From: Ellison, Mark
Sent: 08 April 2024 11:53
To: Harrison, Liz
Subject: Planning App Consultation Request Internal DC/23/95627 for condition 16 (Proposed Local Areas of Play) for Boorley Gardens Phase 2

Landscape comments for DC/23/95627 for condition 16 (Proposed Local Areas of Play) for Boorley Gardens Phase 2

Description: Discharge of conditions application following reserved matters consent RM/18/84466 (pursuant to outline permission O/15/75953, as amended by X/19/84943) for condition 16 (Proposed Local Areas of Play) for Boorley Gardens Phase 2.

MILL22017 11K Sheet 3

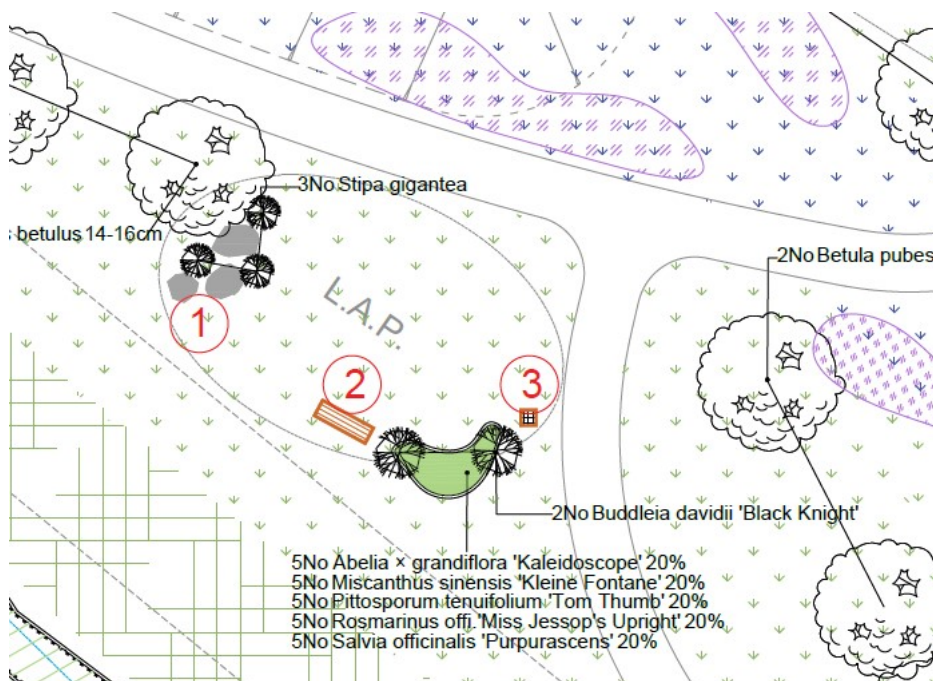
1. The immediate area of the LAP needs to have a specific ryegrass based hard wearing seed mix, or turf specified. The wildflower mix won't be hard wearing enough.

2. The rock area should have more rocks in it and be more interesting. Rocks from play companies tend to be very expensive. I have used rocks direct from a quarry in Somerset in the past in a play area. You'd need to write a short spec, to make sure that there are no sharp edges etc, but otherwise the stone should be fine. There is a risk of some flaking, but my view is that this all feeds into the richness of the play experience. The contact is; Harvey Stone, Ham Hill Masonry Works, Ham Hill, Stoke - Sub - Hamdon, Somerset, TA14 6RW
Phone: +44 (0)1935 824950
Fax: +44 (0)1935 825944

3. The bench should be located on a paved surface, large enough to prevent wear by feet of seated persons and remove the need for strimming around the bench legs.

4. The waste bin is positioned at a curious angle: it should align centrally to a radial line drawn from the centre of the ellipse shape.
5. The planting design should be carefully considered, and each species located. It's not acceptable to delegate the design of this to the contractor. There should be balance in the numbers of each species in relation to their role in the composition and ultimate spread: having equal number of each species is too simplistic an approach. Taller plants should be set properly amongst larger numbers of smaller plants (unless the smaller plants have a

widespread). Please swap the location of the Buddleia nearest the bench with the Stipa furthest from it. The two Buddleia together set up an awkward symmetry and anyway it not a great idea to locate such a bee magnet of a plant so close to a bench. Please add some **clumping** bamboos to the rock area to increase the display and play value. In the past I've used Fargesia robusta 'Campbell', Fargesia rufa and Fargesia nitida 'Volcano' before. The bed on the east side should be enlarged by at least 50%.

6. Display of spring bub planting required.

MILL22017 11K Sheet 7 Some comments repeated from above in whole, in part or part modified

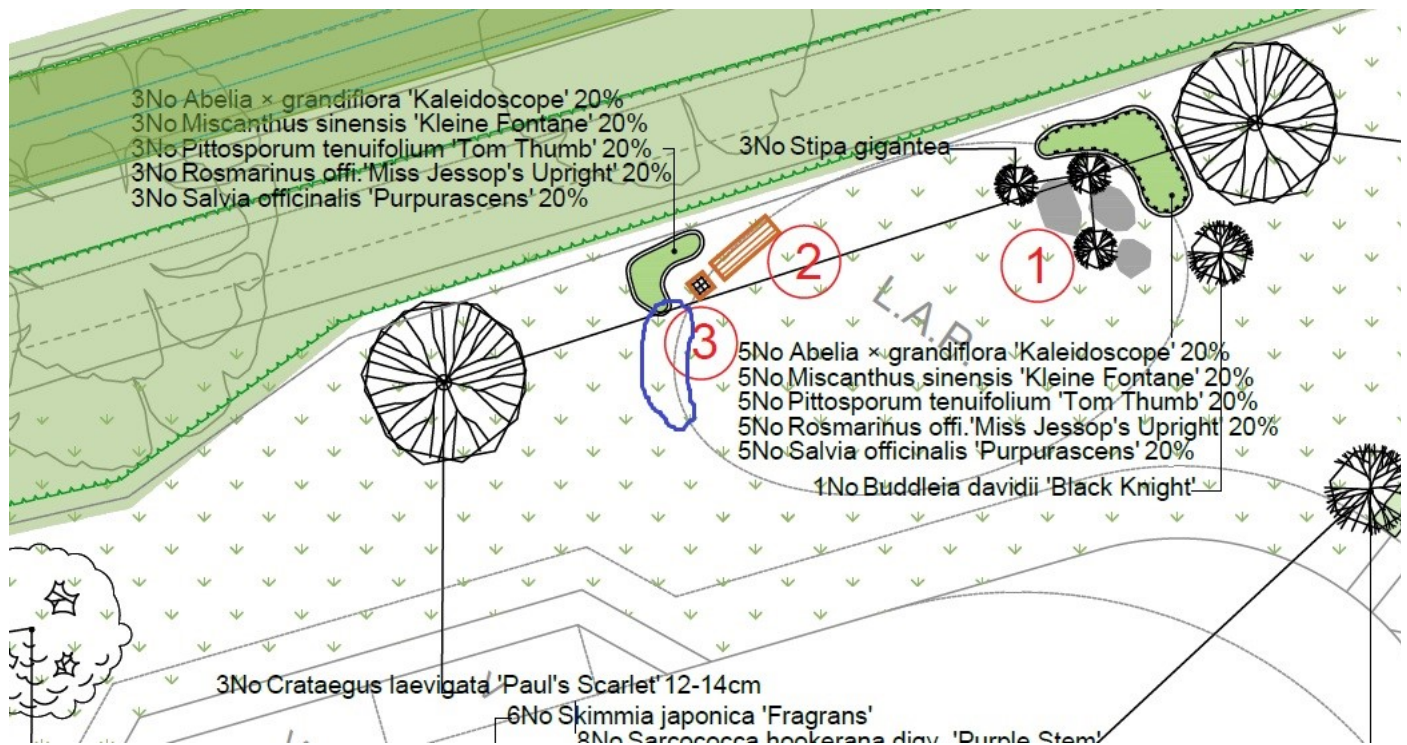
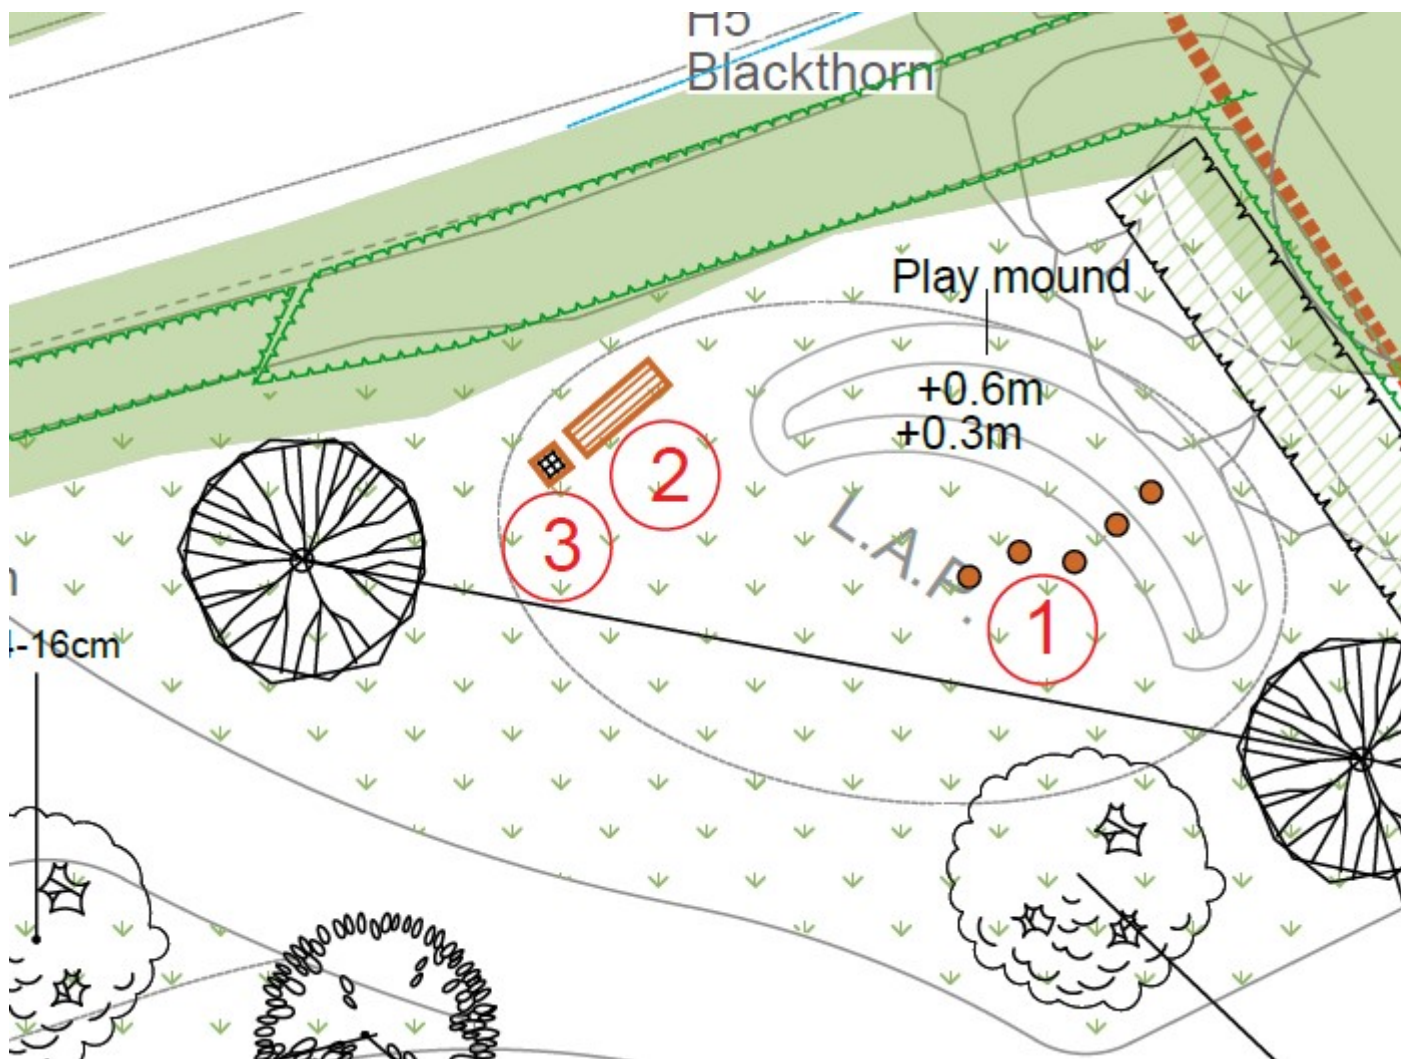
1. The immediate area of the LAP needs to have a specific ryegrass based hard wearing seed mix, or turf specified. The wildflower mix won't be hard wearing enough.

2. The rock area should have more rocks in it and be more interesting. Rocks from play companies tend to be very expensive. I have used rocks direct from a quarry in Somerset in the past in a play area. You'd need to write a short spec, to make sure that there are no sharp edges etc, but otherwise the stone should be fine. There is a risk of some flaking, but my view is that this all feeds into the richness of the play experience. The contact is; Harvey Stone, Ham Hill Masonry Works, Ham Hill, Stoke - Sub - Hamdon, Somerset, TA14 6RW

3. The bench should be located on a paved surface, large enough to prevent grass wear by feet of seated persons and remove the need for strimming around the bench legs.

4. Please position the bin a little further from the bench or perhaps on the east side of the space. It also doesn't work having such a formal relationship in the positioning of the two items in what is a relatively informal setting.

5. To create variety there should be no more than 30% of the shrub/ornamental grass species common to each of the three LAPs. The shape and size of the bed to the west side of the play area isn't in scale with the space: please amend as shown with the blue line above. The planting design should be carefully considered, and each species located. It's not acceptable to delegate the design of this to the contractor. There should be balance in the numbers of each species in relation to their role in the composition and ultimate spread: having equal number of each species is too simplistic an approach. Taller plants should be set properly amongst larger numbers of smaller plants (unless the smaller plants have a widespread). Please add some **clumping** bamboos to the rock area to increase the display and play value. In the past I've used Fargesia robusta 'Campbell', Fargesia rufa and Fargesia nitida 'Volcano' before.

6. Display of spring bub planting required.
